SERVICE INSTRUCTION

ROUTINE MODIFICATIONS

OF THE BING CONSTANT DEPRESSION CARBURETOR

SI-912-012 R1
SI-914-014 R1

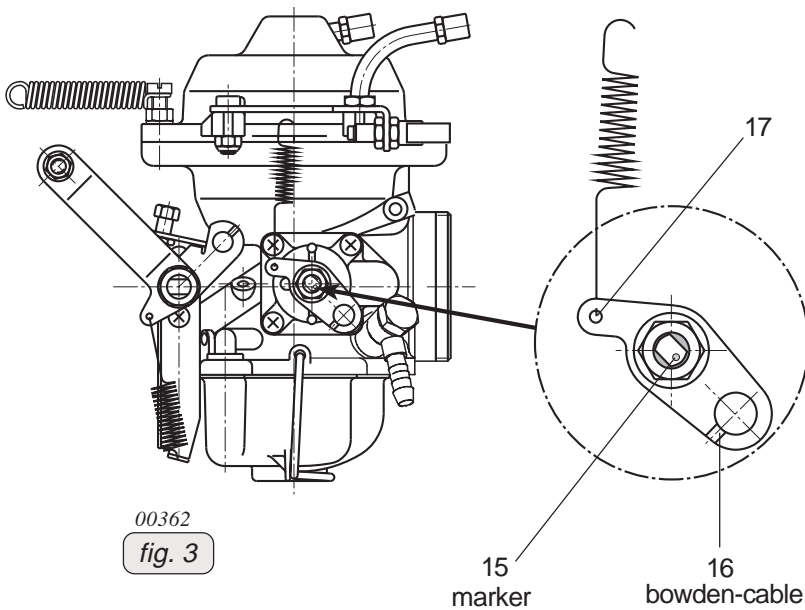
3.2.1) Damping of the jet needle

Damping of the jet needle has been standardized through the additional O-ring (1) part no. 950430 and fixation screw (2) part no. 961292 as already known from the ROTAX[®] 912 S/ULS/ULSFR.

3.2.2) Jet needle position

The jet needle position has been standardized to position 3 on the ROTAX[®] 912 Series.

In the case of the ROTAX[®] 914 Series, the standard jet needle position has been determined to be position 1 at carburetor 1/3 and position 2 at carburetor 2/4.

3.2.3) Fuel line connector (fuel supply)

Apply screw securing agent TufLok onto fuel line connector (3) part no. 941853 as has been done for the fixation screw. Depending on engine type, order the appropriate fuel line when procuring spare parts.

3.2.4) Gasket for choke housing

The material of choke housing gasket (4) was changed with the part no. 950030 retained and is now black instead of red previously.

3.2.5) Gasket in the chambertop

A further change of material was introduced on the gasket under the chamber top (14) part no. 961250 blinding shim.

3.2.7) Float needle valve

The float needle valve (5) has been standardized to part no. 261706 having medium spring power.

3.2.8) Spring (Idle mixture screw)

The material for the spring (6) of the idle mixture screw was changed, and the part no. 239463 was introduced therefore.

3.2.9) O-Ring (Idle mixture screw, Idle jet 35)

The O-ring (7) material was changed, and the part no. 831712 was introduced therefore.

3.2.10) Throttle valve lever / Cable support

The spring retainer has been improved for throttle lever (8) and cable support (9). Sleeve (11) and (10) was introduced. The part no. of the new throttle valve lever assy. is 963020 for carb. 2/4 and 963025 for carb. 1/3. The part no. of the new cable support assy. is 961267 for carb. 2/4 and 961262 for carb. 1/3.

3.2.11) Attachment screw (float chamber ROTAX®) (914 F/UL)

Replacing the sealing ring, an O-ring (12) part no. 631770 including changed attachment screw (13) (attachment screw assy. part no. 963281) has been introduced.

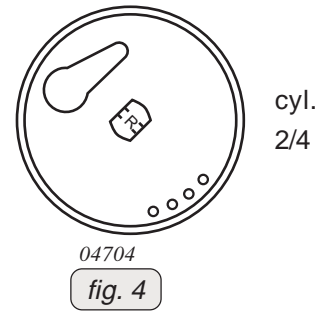
3.2.6) Markings on the rotary disc valve

■ CAUTION: The choke shaft has a marking point (15) (see fig. 2 and fig. 3). This marking needs to point towards the bowden-cable fitting (16) in order to function correctly.

However carburetors with the following serial number have their marking pointing towards the spring retainer (17). When performing maintenance work, remove this marking point and remark correctly.

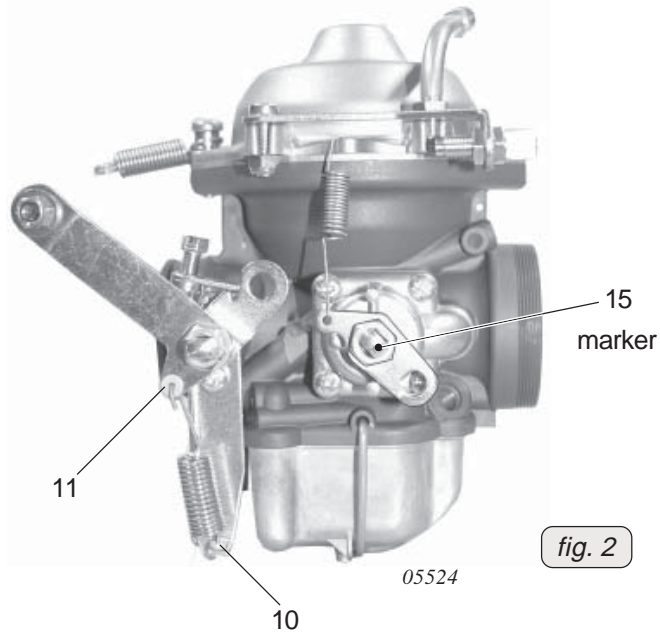
3.2.13) Markings on the rotary disc valve-inside

◆ NOTE: The rotary disc valve has L and R markings. The shaft marked with L is meant for the carburetor for cylinder 1/3, and the R marking is meant for the carburetor for cylinder 2/4. Fig. 4 represents the marking positions on the inside choke shaft.

■ CAUTION: The choke device will not function with the choke housing mixed up.
